**ISO/IEC JTC1/SC29/WG11
MPEG93 / ____
September 1993**

Source: Apple Computer - Gary Demos, David Singer, Joseph Stampleman
Title: MPEG-2 Transport Stream Mapping and Adaptation Layer Fields for ATM
Committee: Systems

Subject: Serious flaws in interoperability in the GA proposal

To: Robert Sanderson, Kodak, Chair of FCC ATV Interoperability Review Board
& Mike Liebhold, Apple Computer, Vice Chair
cc: Branko Gerovac, Digital Equipment, Secretary

Possible MPEG-2 ATM Adaptation Layer Including RS-Code Flag

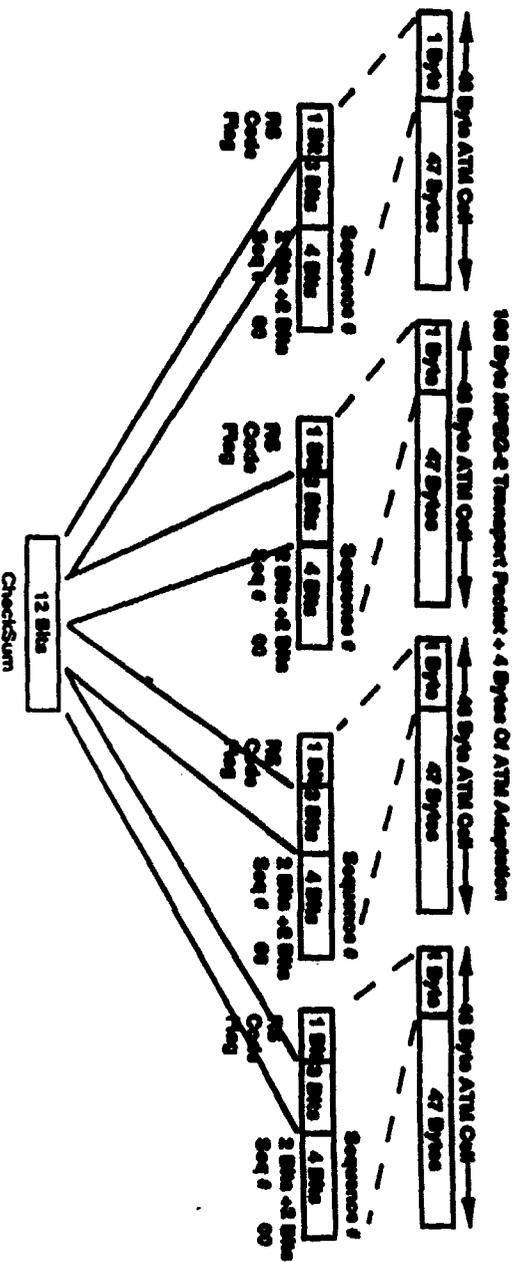
It appears that the appropriate place to identify which cells are involved in error correcting codes is in the MPEG-2 transport adaptation to ATM. Thus, it may be appropriate to consider modifying the proposal by Alexander (Sandy) Macdonald of Kallada and Randy Sharpe of BBT to add a bit for an error correction code flag. This bit would indicate whether the particular ATM 48-byte cell contains a quarter of an MPEG-2 transport packet, or whether it contains 47 bytes of Reed-Solomon (or other error correcting) code.

The following modification to the above proposal adds this RS Code flag, and reduces the number of bits in the sequence counter from 5 to 4:

The inclusion of the RS-Code flag in the high bit allows easy byte sign detection of the presence of absence of RS-Code data in each ATM cell. Maintaining 4 bits of sequence number and 3 bits (for 12 bits) of CheckSum still provides adequate ranges.

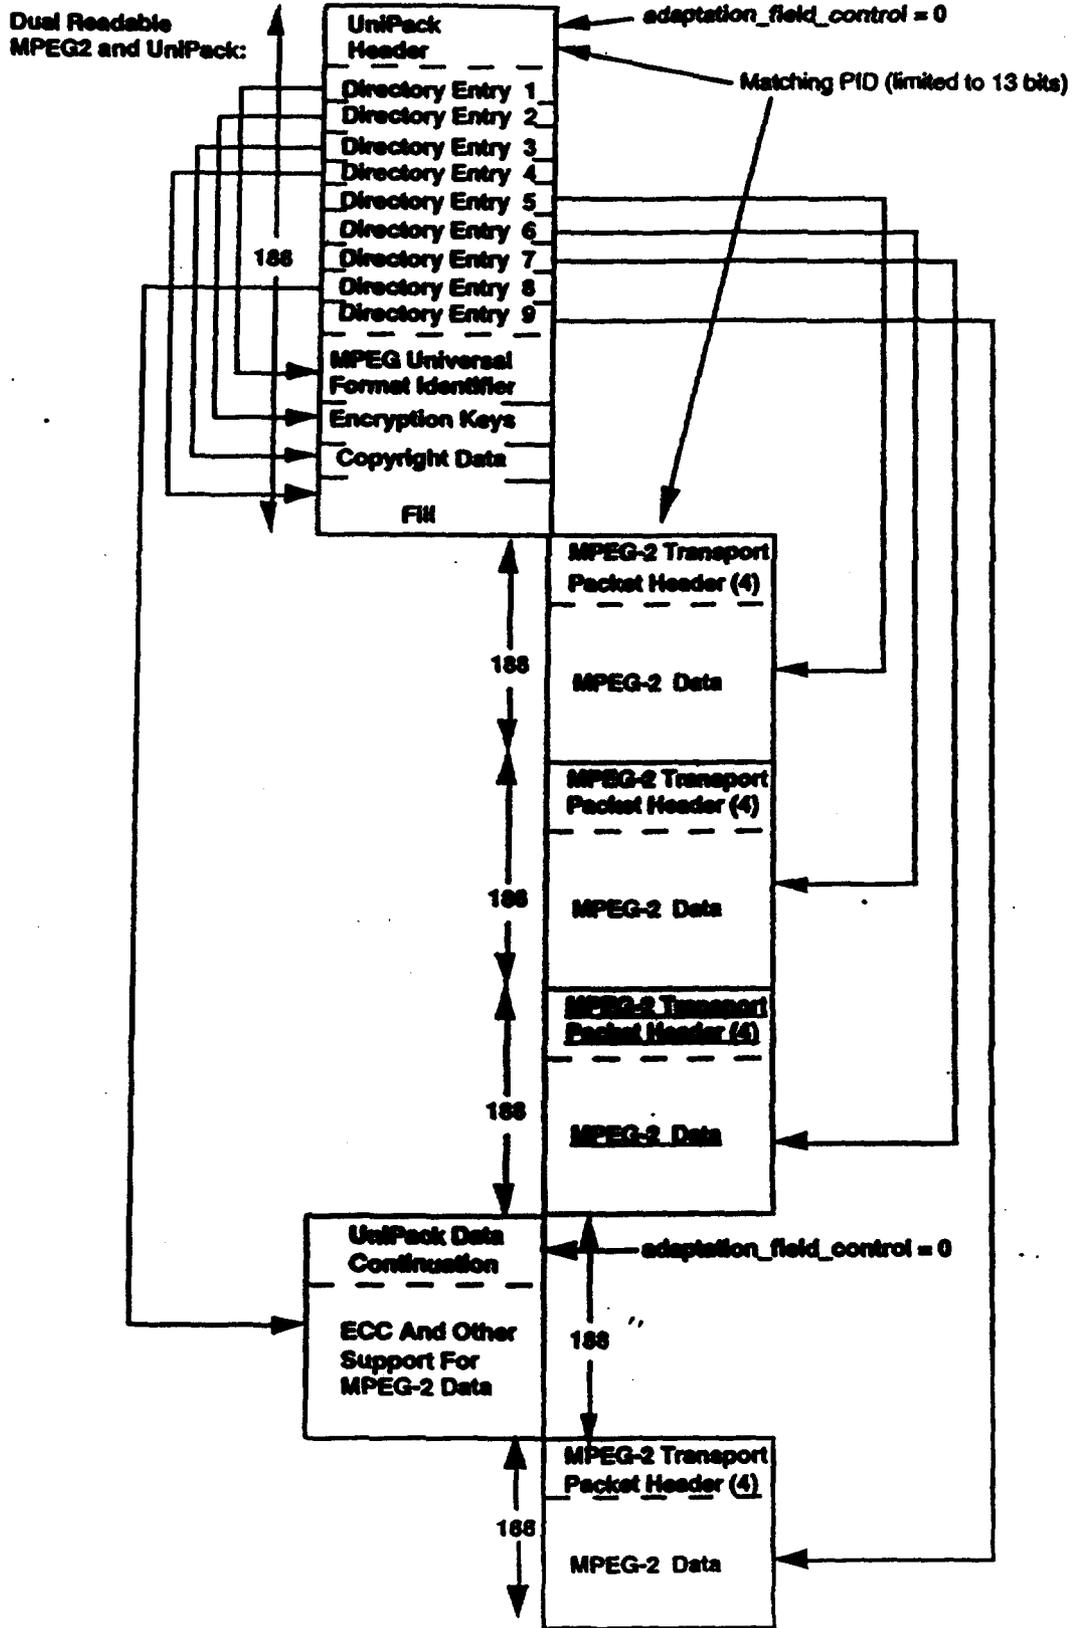
The above table shows a continuation packet for payload for the UniPack header which was issued previously on the same PID. The data_bytes may contain other information such as larger continuity counters, a 16 bit channel number (program number), and other information, as described in the UniPack header's initial directory.

On the following page, the combination of UniPack and MPEG-2 is shown, with the data stream readable from both MPEG-2 and UniPack. The directory entries describe each MPEG-2 packet individually. It is also possible to have a single identifier, descriptor, or directory entry for a collection of MPEG-2 transport_packets.
